1600 W. Lincoln Avenue Project

Subject: Response to City of Anaheim Review Comments, OTH2018-01082, Proposed Multi-Family Residential Development and Parking garage, 1600 W. Lincoln Avenue, Anaheim, California.

Reference: First Review Comments Pertaining to the Referenced Report for the Proposed Multi-Family Development & Parking Garage at 1600 W. Lincoln Avenue, Anaheim, California, OTH 2018-01082, Dated/Stamped by the Public Works Engineering on July 23, 2018, prepared by CEM Lab, dated August 13, 2018 (File No. CEM2018-119).

Geotechnical Due-Diligence Evaluation, Proposed Multi-Family Residential Development and Parking garage, 1600 W. Lincoln Avenue, Anaheim, California, prepared by Albus-Keefe & Associates, Inc., dated October 6, 2018 (J.N.: 2623.00).

| SAMPLE LOCATION | SAMPLE TYPE | SAMPLE DESCRIPTION |
|---|-----------------------------------|--------------------|
| | | Plate No: B-2 |

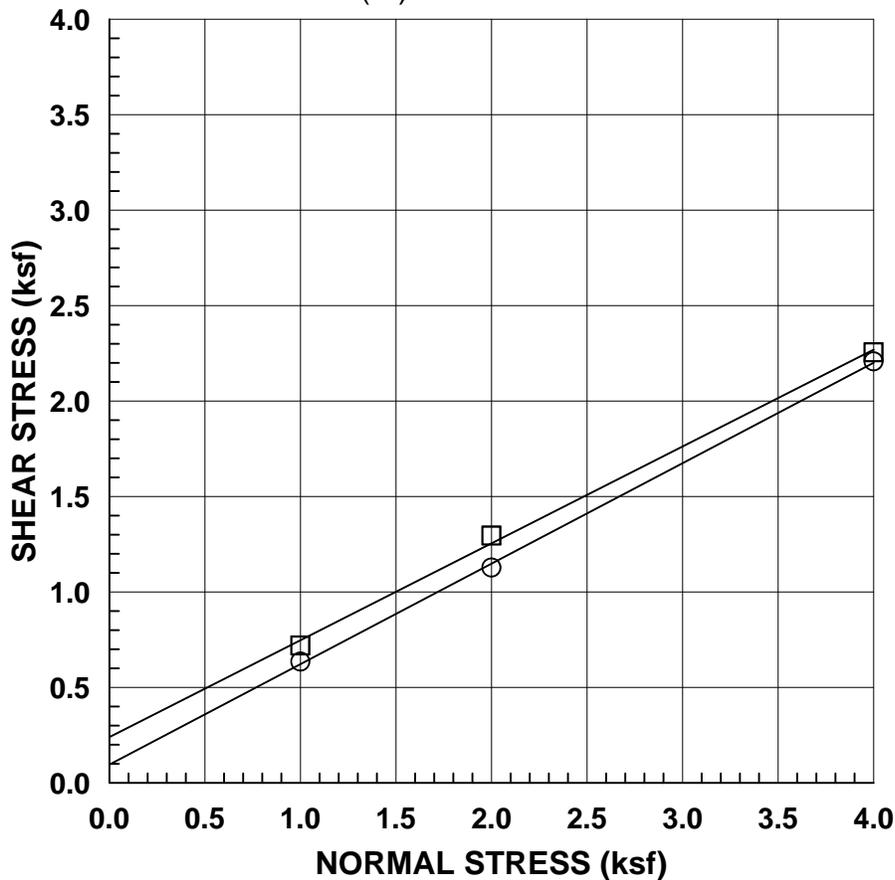
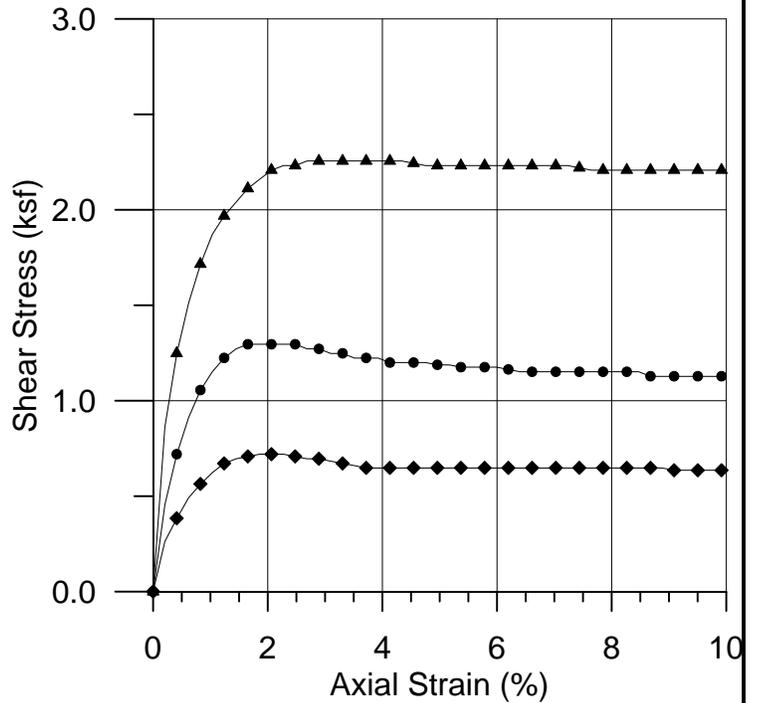
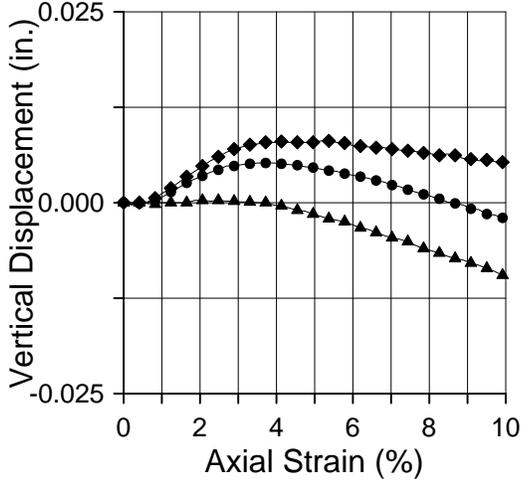
In reference to the laboratory test program in Appendix B, the Direct Shear Test in Plate No. B-2 missing the essential data such as internal friction angle and cohesion.

- 3.4 In reference to the laboratory test program in Appendix B, the Direct Shear Test in Plate No. B-2 missing the essential data such as internal friction angle and cohesion.

4. In reference to the laboratory test program in Appendix B, the Direct Shear Test in Plate No. B-2 missing the essential data such as internal friction angle and cohesion.

A revised copy of Plate B-2 is attached herein, and now includes friction angles and cohesion values for both Peak and Ultimate conditions.

| | | Plate No: B-3 |

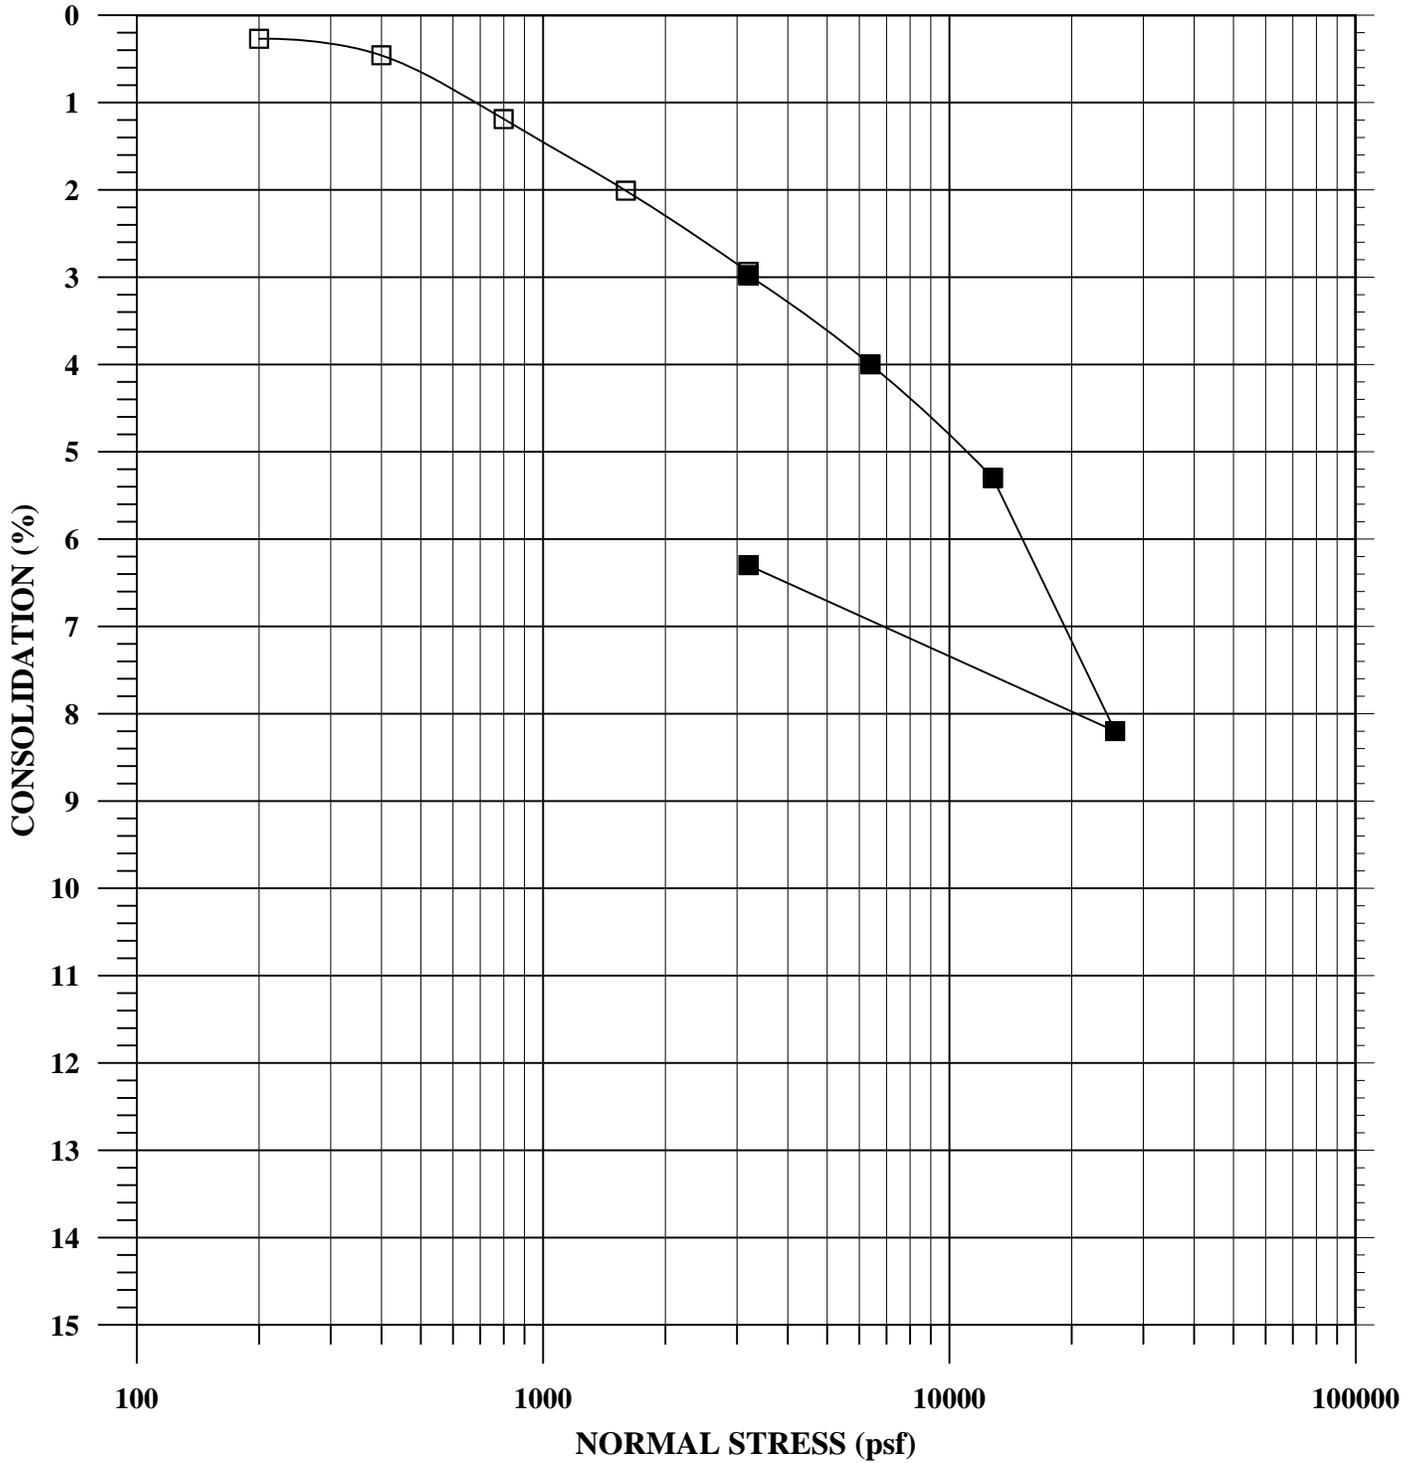
Referring to the laboratory test program in Appendix B, the consolidation test results in Plate No. B-3. It is unlikely for a soil sample with an initial dry density of 131.8 pcf to consolidate over 8.0%. It also contradict the data at depth 5 ft in Boring B-2. Therefore, we believe the laboratory test is erroneous.

- 3.5 Referring to the laboratory test program in Appendix B, the consolidation test results in Plate No. B-3. It is unlikely for a soil sample with an initial dry density of 131.8 pcf to consolidate over 8.0%. It also contradict the data at depth 5 ft in Boring B-2. Therefore, we believe the laboratory test is erroneous.

5. Referring to the laboratory test program in Appendix B, the consolidation test results in Plate No. B-3. It is unlikely for a soil sample with an initial dry density of 131.8 pcf to consolidate over 8.0%. It also contradict the data at depth 5 ft in Boring B-2. Therefore, we believe the laboratory test is erroneous.

The initial dry density of 131.8 pcf indicated on Plate No. B-3 was inadvertently reported in error. A corrected copy of Plate No. B-3 is attached herein.
